# Access Compliance Report

## Public Rights-of-Way

| Intersection ID: 24428                  | Main Street: PRESCOTT_POND_LN | Cross Street: SAINTFIELD_PL             | Location: NW           |
| ADA ID: E1E4E774C507                    | Ramp Type: PerpDiag           | Initial Pass/Fail: Fail                 | Overall Compliance: No |

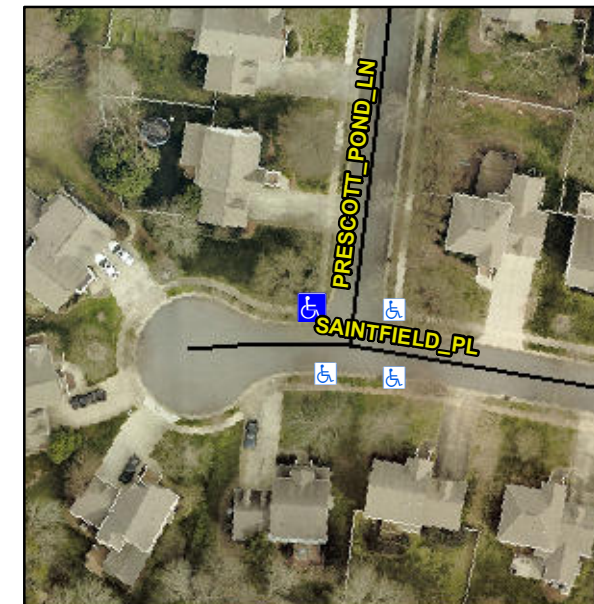
**R304.2.2, R304.5.3**

| Compliance | Description           | Data | Compliance | Description                 | Data |
|------------|-----------------------|------|------------|-----------------------------|------|
| N/A        | Ramp Length (in)      | 58.0 | No         | Ramp Slope (%)              | 8.5  |
| Yes        | Ramp Width (in)       | 48.0 | No         | Ramp XSlope (%)             | 2.2  |

**Remove & Replace Curb Ramp With Two New Directional Ramps or Equivalent.**
